**METROPOLITAN GOVERNMENT OF NASHVILLE AND DAVIDSON COUNTY**

**STAFF RECOMMENDATION**

**1112 Forrest Avenue**

**Application:** New construction – outbuilding; Setback Reduction

Figure 2. Rear property line of 1112 Forrest Avenue.

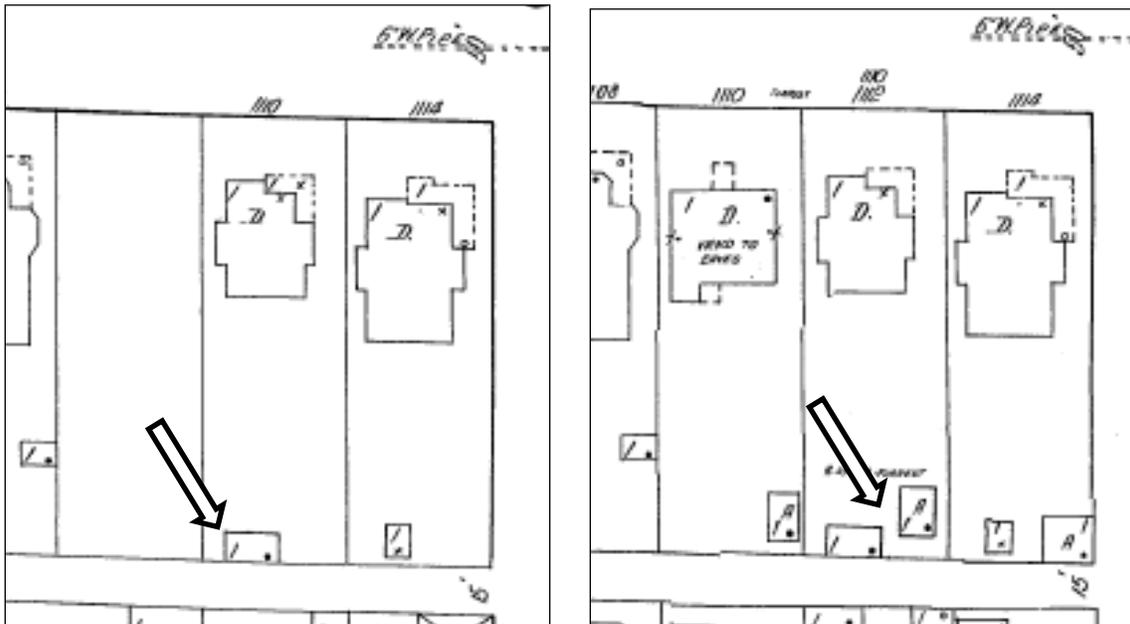
Location & Setbacks. The applicant is proposing to construct an outbuilding at the rear of the property, in the southeast corner of the site, which is a typical location for outbuildings (Figure 2). The structure will be three feet (3') from the east side property line and approximately twenty-five feet (25') from the west side property line, both of which meet the base zoning setbacks. The outbuilding will have garage doors which face the alley. Base zoning requires that the structure be ten feet (10') from the rear property line, but the applicant is proposing to locate the structure just five feet (5') from the rear property line. Staff finds the proposed setback reduction to be appropriate in this instance because an analysis of the current conditions of the area shows that there are several outbuildings in the immediate vicinity that sit five feet (5') or less from the rear property line. In addition, the Sanborn maps from 1914 and 1951 show that this site formerly had an outbuilding that sat on the rear property line (Figures 3 & 4). Staff finds

the setbacks, location, and orientation to meet Sections II.B.3, II.B.6., and II.B.8 of the *Lockeland Springs-East End Neighborhood Conservation Zoning Overlay: Handbook and Design Guidelines*.

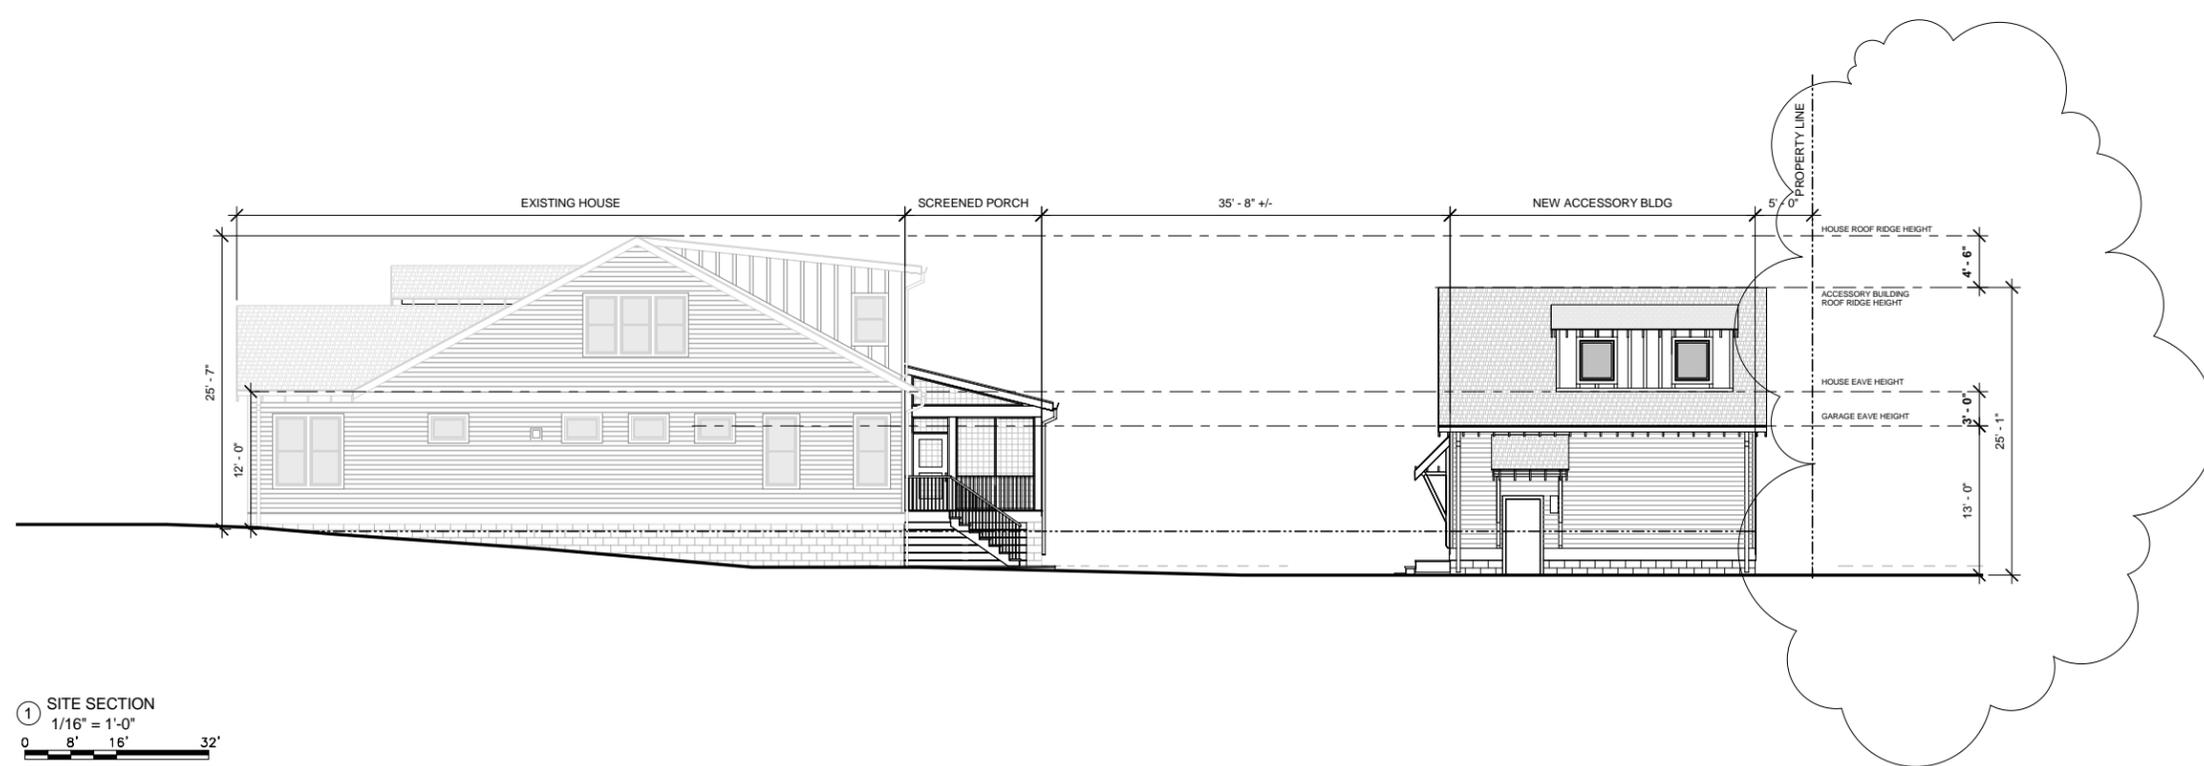
**Height Scale.** The proposed accessory structure will be twenty-two feet wide by twenty-six feet, seven inches deep (22' X 26'7"). It will have a total footprint of five hundred and eighty-seven square feet (587 sq. ft.), which is about one-fourth (1/4) the footprint of the primary structure. The garage will be one-and-a-half stories in height, with an eave height of approximately thirteen feet (13') from grade and a ridge height of

approximately twenty-five feet, one inch (25'1") from grade. By comparison, the primary structure is also one-and-a-half stories in height with an eave height of twelve feet (12') and a ridge height of twenty-five feet, seven inches (25'7"). The site slopes several feet from the front of the property to the rear of the property so that although the outbuilding is only six inches (6") shorter than the primary structure, it will be four feet, six inches (4'6") shorter than the house when the slope is taken into consideration. Typically, staff asks for a larger difference between the height of the primary structure and that of the outbuilding. However, in this case, the footprint of the structure is so modest that the outbuilding will be sufficiently subordinate to the house even though it is of a comparable height. Staff therefore finds that the height and scale of the outbuilding meets Sections II.B.1, II.B.2., and II.B.8 of the *Lockeland Springs-East End Neighborhood Conservation Zoning Overlay: Handbook and Design Guidelines*.
